NEW ELEMENTARY SCHOOL  
9801 HIGHLAND KNOLLS DR  
BAKERSFIELD  
CALIFORNIA  
93306

FOR:  
BAKERSFIELD CITY SCHOOL  
DISTRICT  
1300 BAKER STREET  
BAKERSFIELD  
CALIFORNIA  
93305

SHEET TITLE  
**LIGHTING PLAN  
BUILDING D**  
SHEET IDENTIFICATION NUMBER  
**E-132D**  
SHEET OF

**RFI 163**

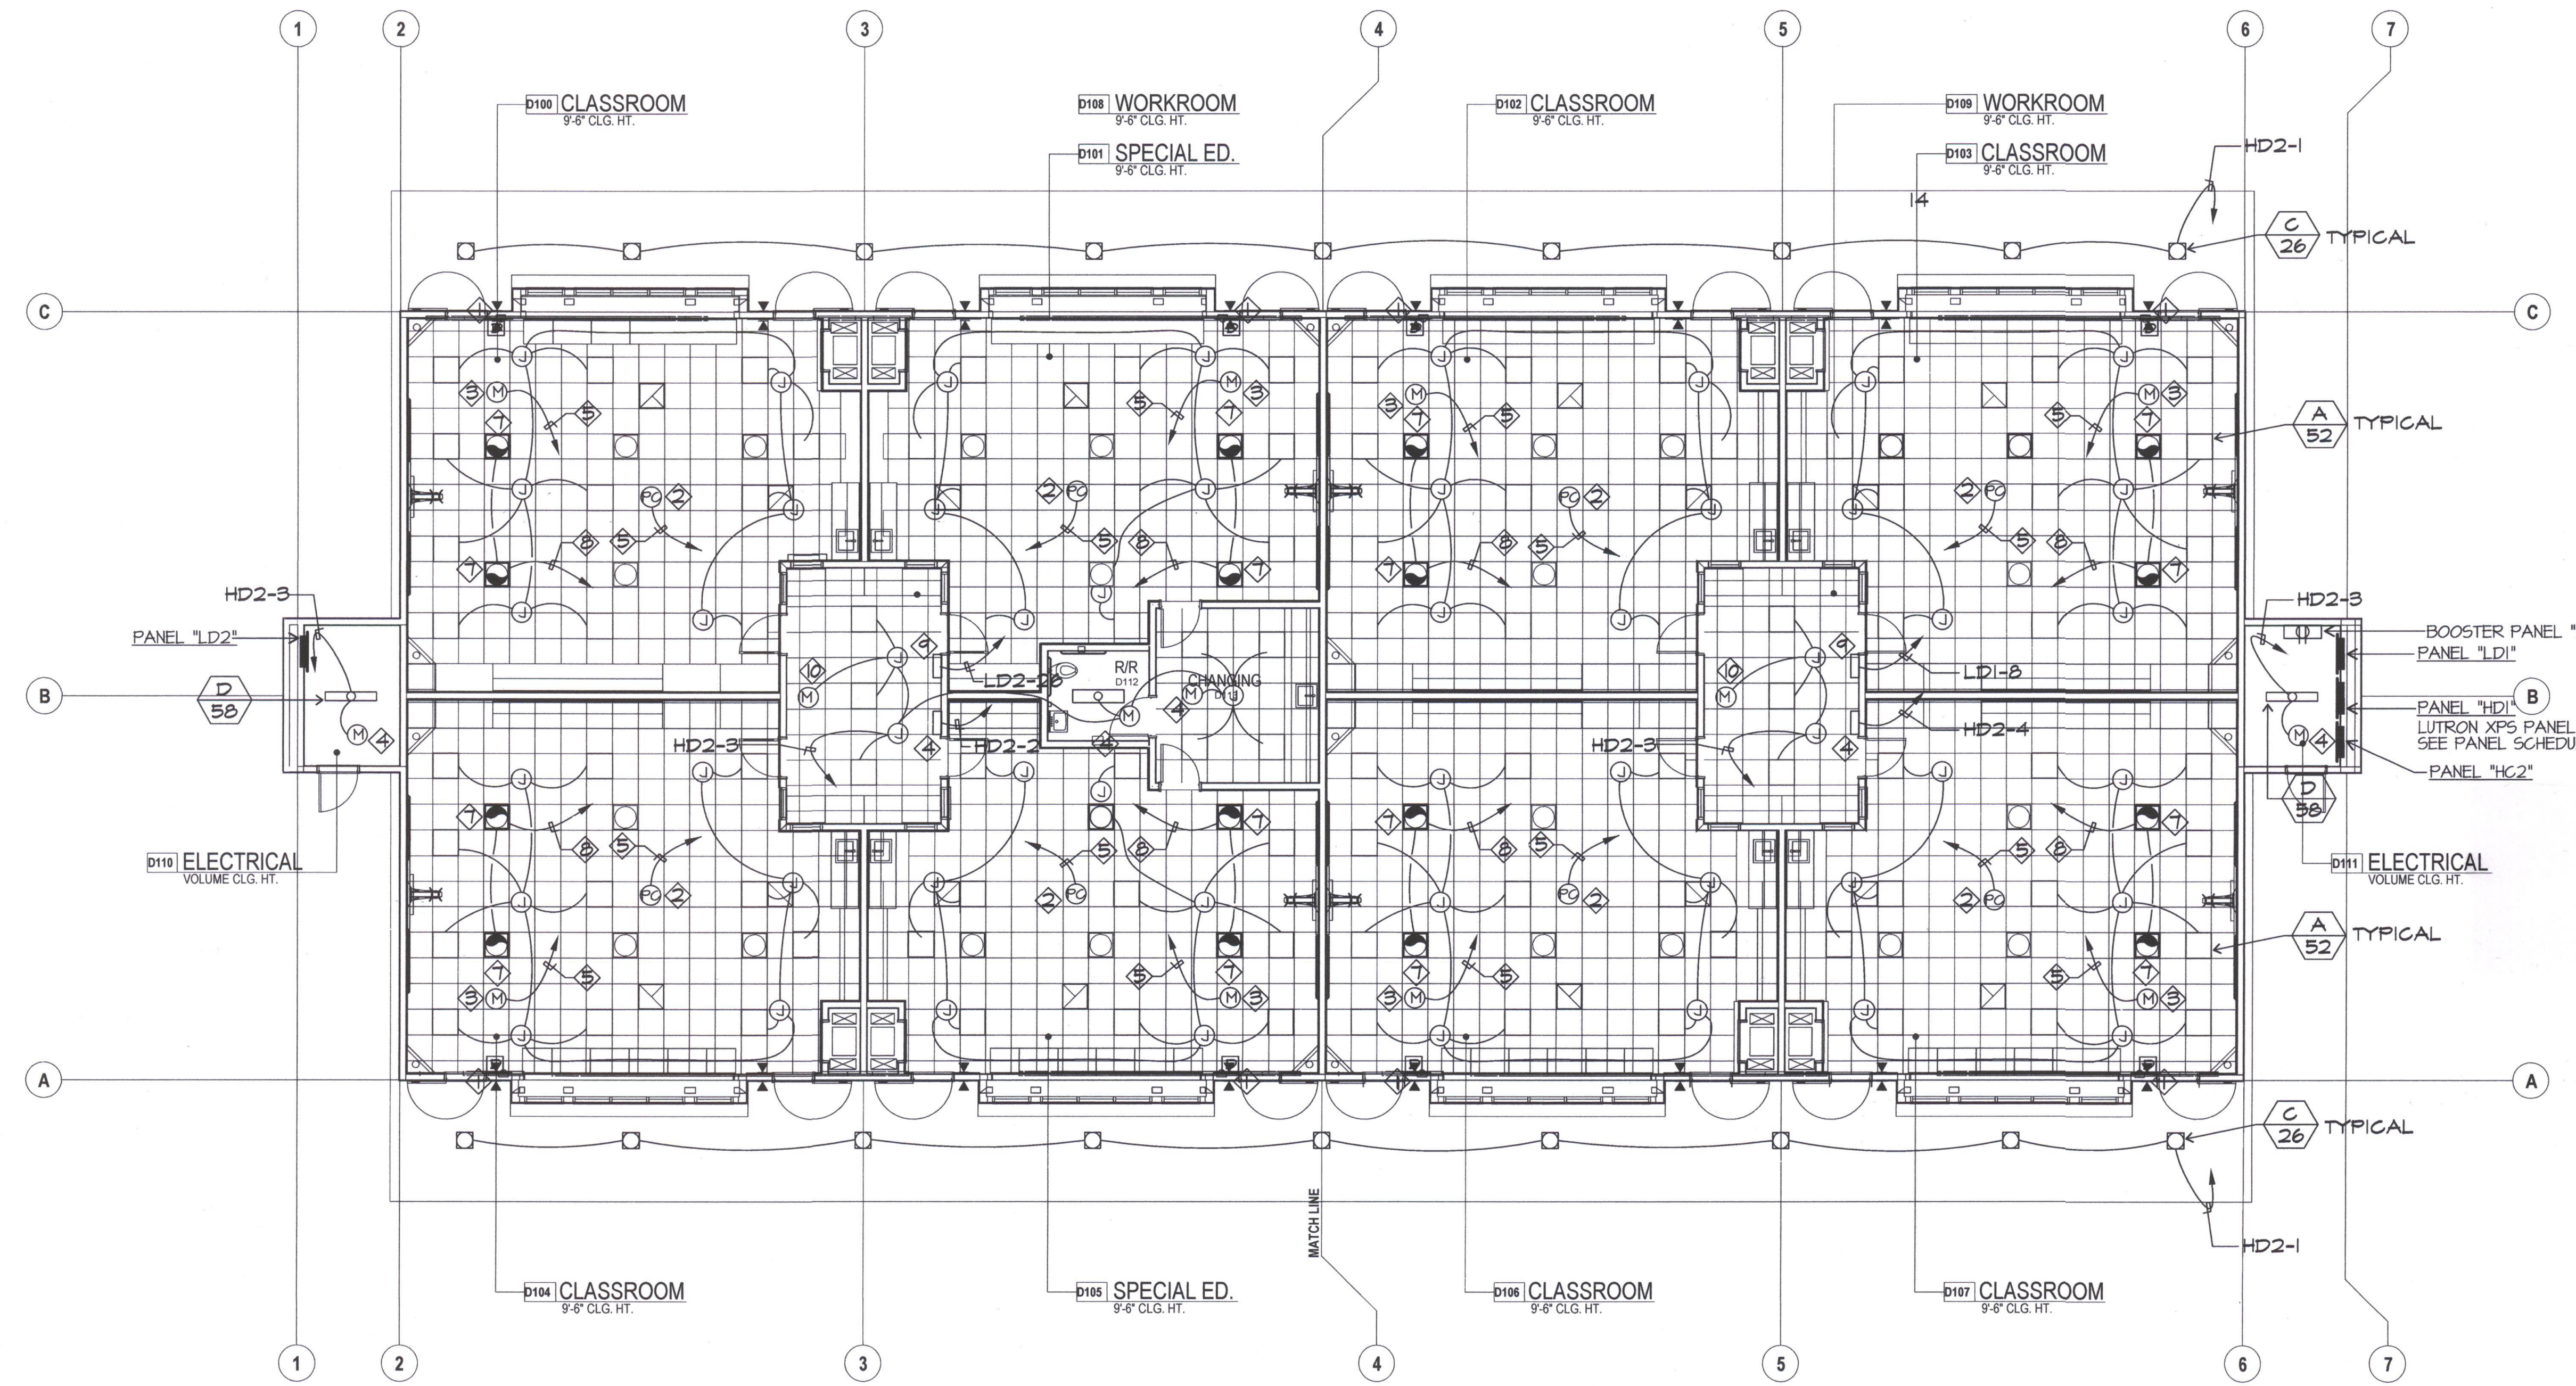
Request:  
RDM Electric - 12/9/12  
Reference Sheets E-000, E-132C, E-132D, E-132E, E-132F, E-132G, E-132H, E-132I & Lighting Submittal  
The General Notes on the Electrical Plans show the lighting dimmers to be installed for the lighting at 48" to top of box and the light switches to be installed at 42". A 5 button Lutron wall station is shown to be installed for the lighting controls in the classrooms. Please provide mounting height (elevation) for the classroom lighting control wall stations.

Request:  
RDM Electric - 1/3/13  
Reference Sheets A131D & E132D  
The Electrical Plan for Building D shows (4) Type A light fixtures, which are 2x2 linear fixtures, to be installed in Room D113. The Architectural Plan for Building D shows (4) 1x4 light fixtures to be installed in a hard ceiling in Room D113. Should these (4) light fixtures in Room D113 be Type D and not Type A? Please advise.

RDM Electric - 9/18/13  
Reference RFI #292 & Sheets E132C, E132D, E132E, E132F, E132G, E132H, E132I, E132J & E132K  
For the response to RFI #292, the schedules in the classrooms are to be controlled via an Energi Savr Node. However, per the attached cut sheets, the schedules appear to need separate DC switching to be controlled, which is not shown on the drawings. The plan only shows to supply 120V to the schedules via the Energi Savr Node. Do the classrooms need DC switching to be added as a means of controlling the schedules? If so, please advise on the requirements.

Answer:  
Joseph W. Covington - Ordiz-Melby (12/12/12)  
Install all switches and dimmers at 42" to the center of the box.

Answer:  
Ed Smith - OMA - 1/3/13  
All ceilings in Special Ed restrooms and changing rooms are hard ceilings, therefore, all fixtures in Special Ed restrooms and changing rooms are to be Type D surface mount.

John Heston - JMPE - 9/18/13  
Contact classroom on Energi Savr Node will operate schedule shutter. We verified this with Substube and Lutron.
